ORDINANCE NO. O2019-12

AN ORDINANCE APPROVING A SPECIAL USE PERMIT FOR A PLANNED UNIT DEVELOPMENT AND A FINAL PLAT OF SUBDIVISION FOR THE LEXINGTON TRACE TOWNHOME SUBDIVISION SOUTH AND WEST OF ROUTE 59/ROUTE 56 INTERSECTION

Re: Lexington Trace
Butterfield Road and Illinois Route 59
Final Engineering Plan Review

The Lexington Site Improvement Plans has been stamped “APPROVED WITH CONDITIONS” and the following comments should be addressed as part of the building permit process:

PROJECT: LEXINGTON TRACE
 WARRENVILLE, ILLINOIS
 SHEET NO.: **SAW2**
 DATE: 12/20/18
 JOB NO.: 1840 S&C
 DESIGNED BY: TBL

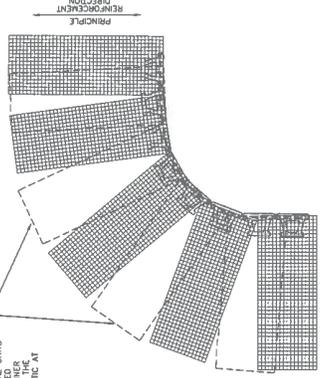
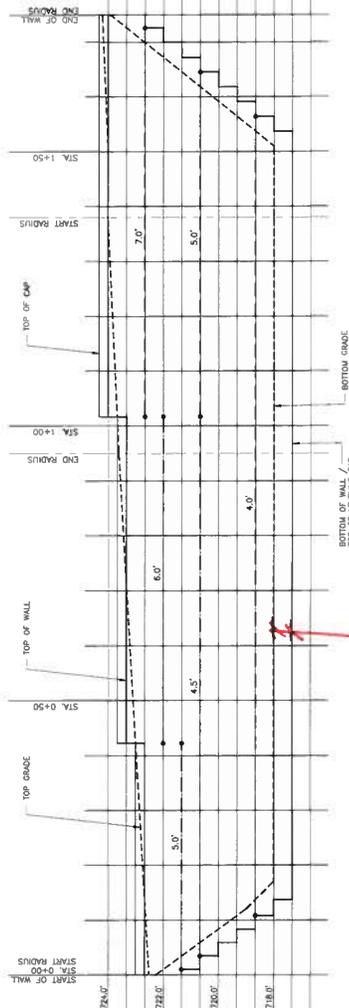
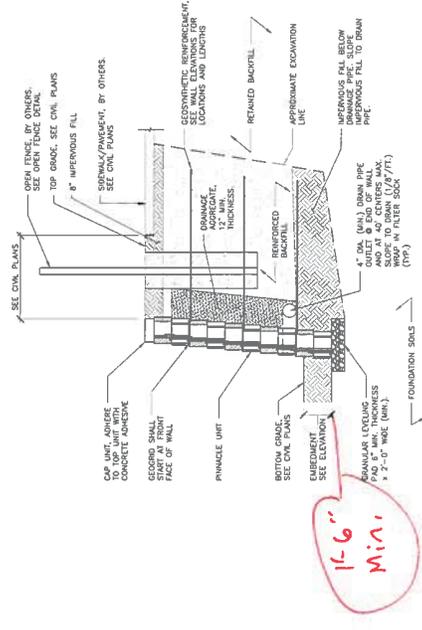
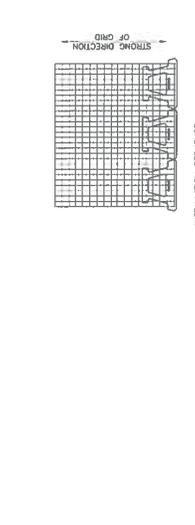
1. Updated City of Warrenton Standard Specifications
2. Structural Shop Drawing markup
3. City of Warrenton Decorative Street Light Details

12' Ornamental Street Light Detail (32W)

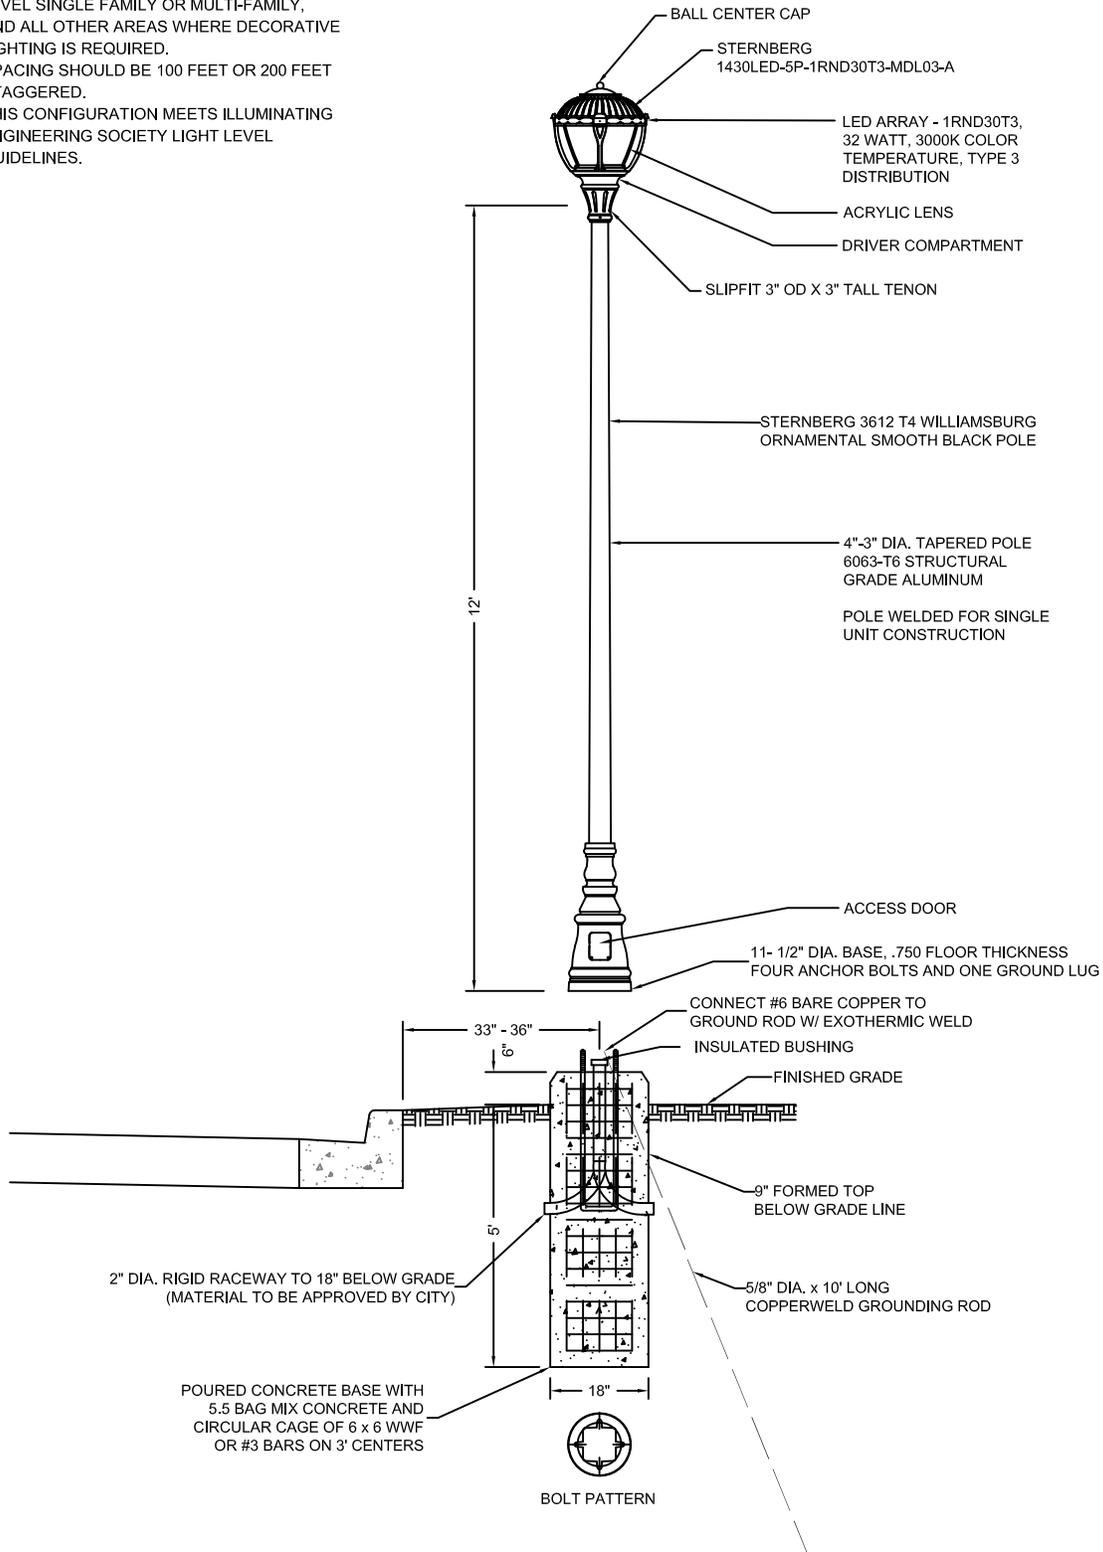
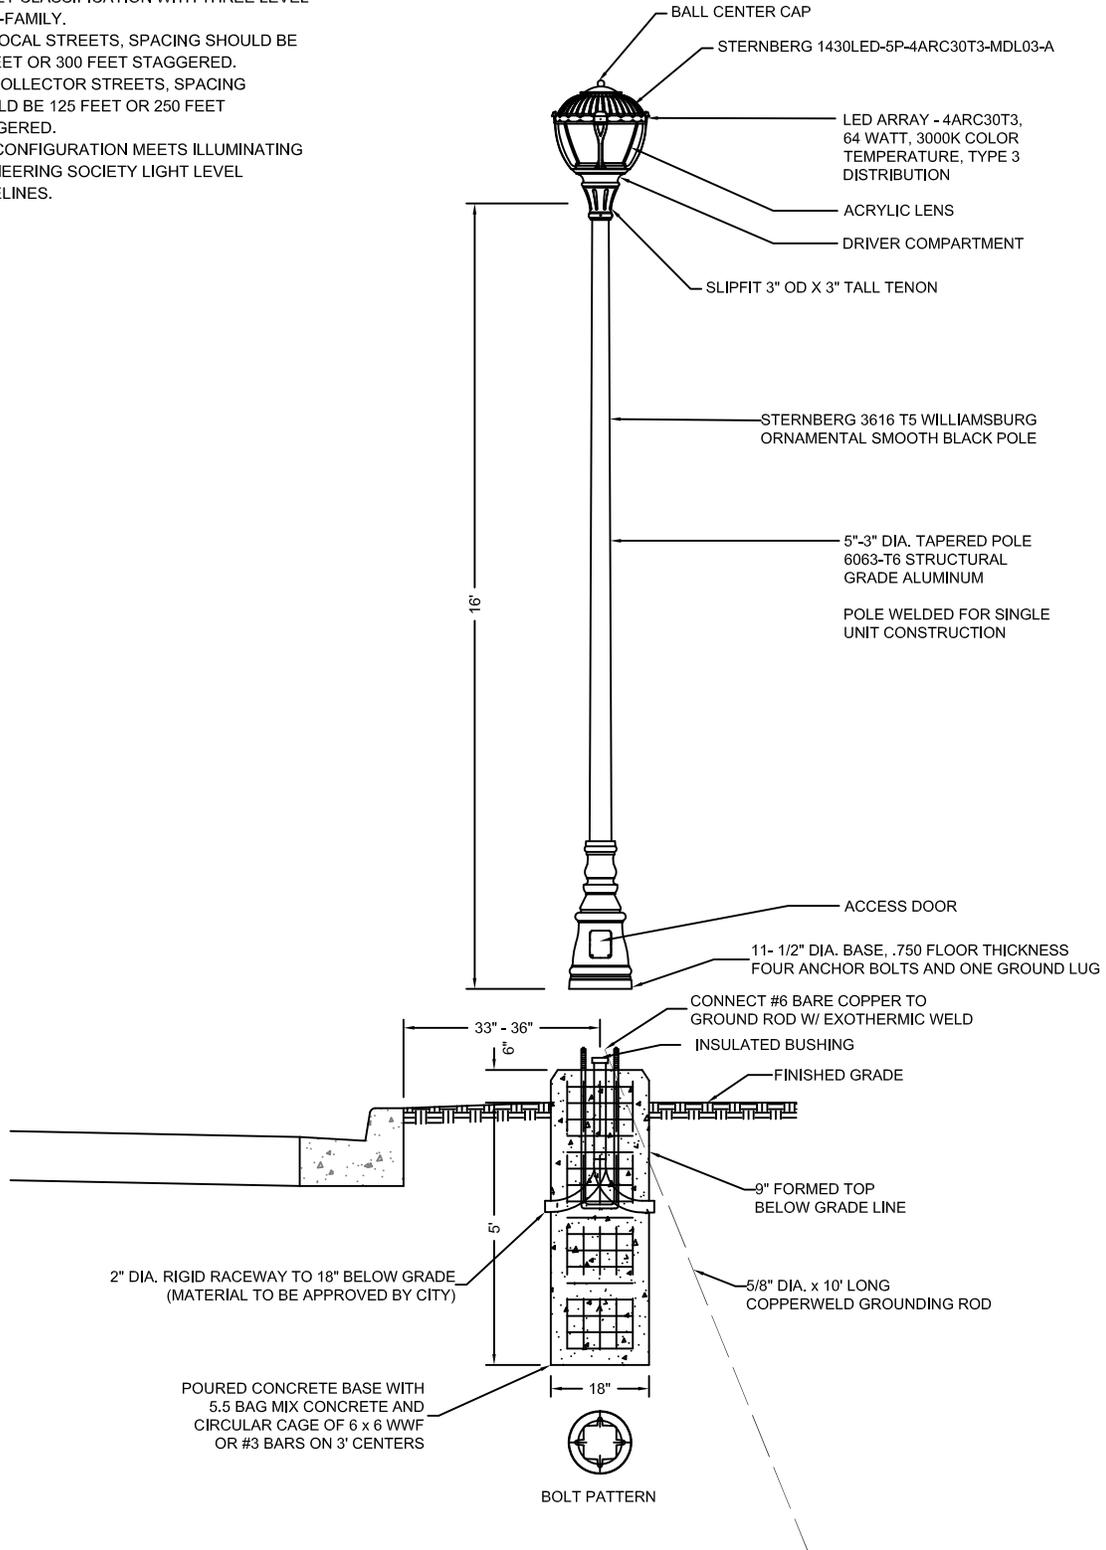
- p. **New Comment:** Update C10.4 Decorative Street Light details with the attached.
3. **New Comment:** Check landscaping trees to ensure they don't conflict with underground utilities. Centerline of trees should be a minimum 4' away from the centerline of the utility. This issue is mostly directed at the street trees on Estes, but it occurs in some other areas of the development.
